Mobile Intel® 945 Express Chipset Family

Specification Update

November 2007

Figure 37. Mobile Intel 945GMS Express Chipset Package FCBGA

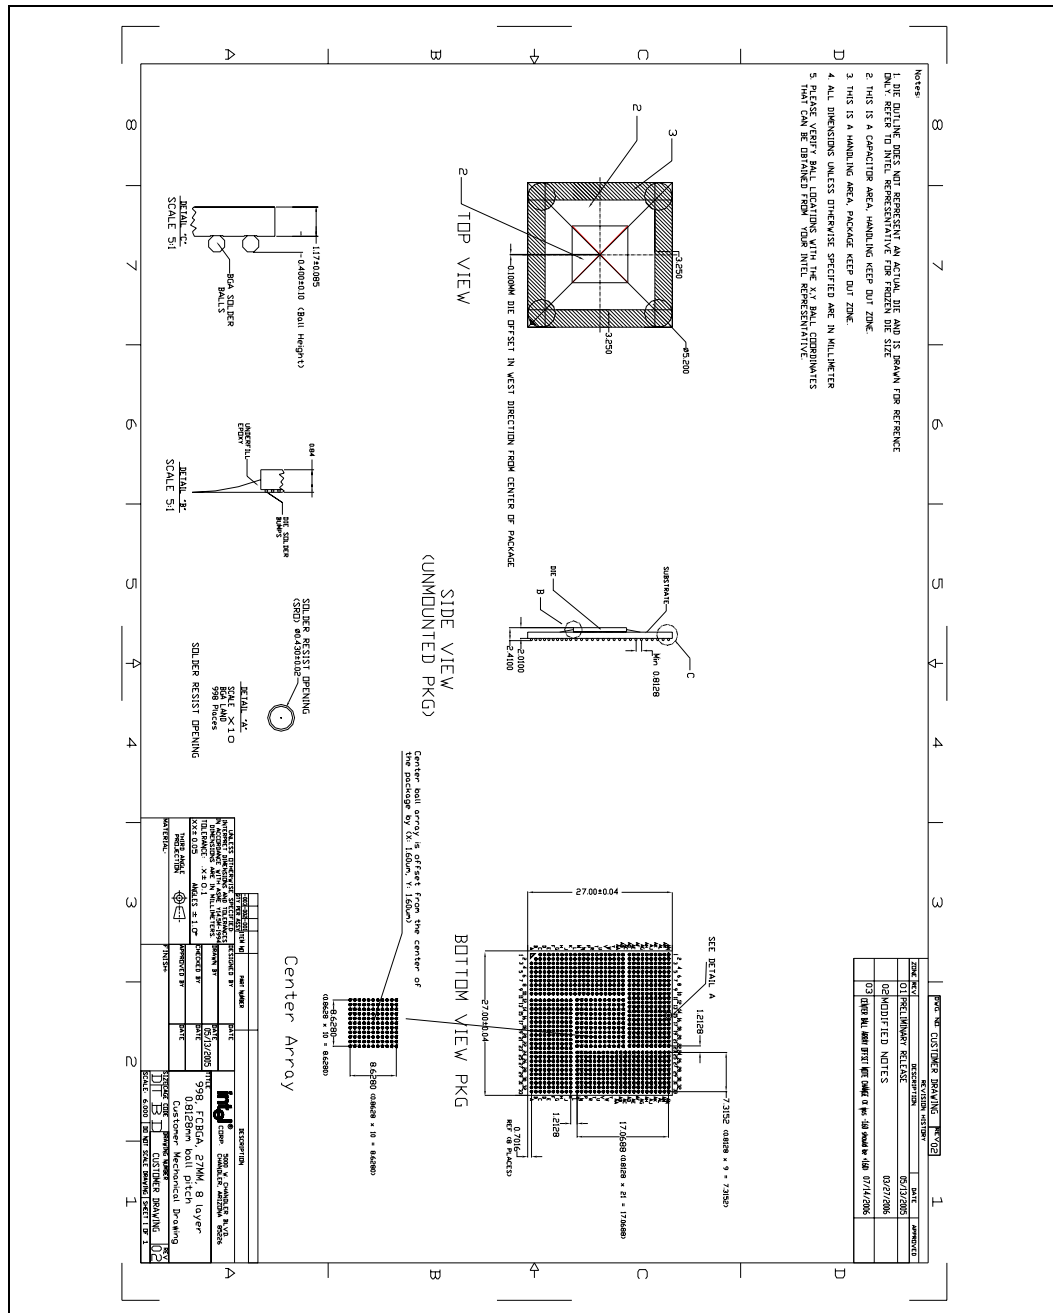
2. Replaced the Diagrams in Figure 37 and Figure 40

The Center Array view has been changed from Top View to bottom view.

Figure 40. Mobile Intel 945GMS Express Chipset Package FCBGA (Bottom View)

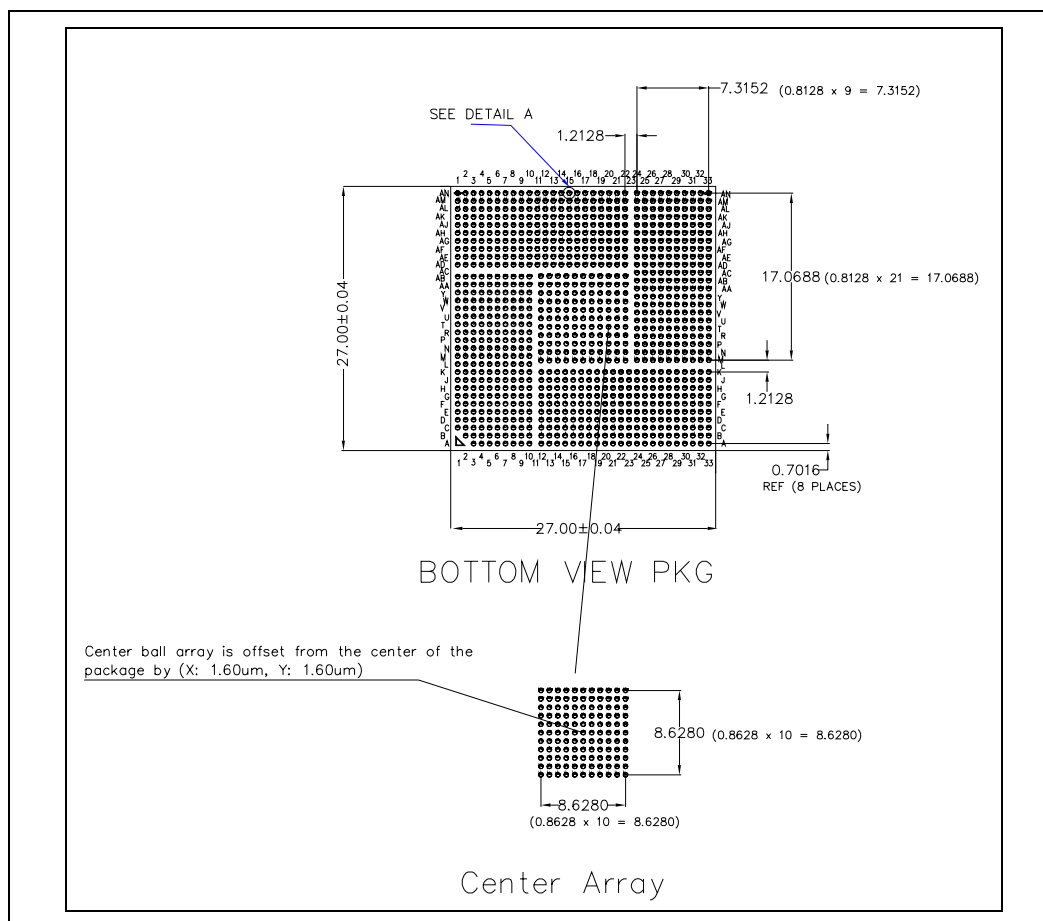
The Center Array view was incorrectly shown from the Top. This has been changed to bottom view. The offset information has also been accordingly updated.
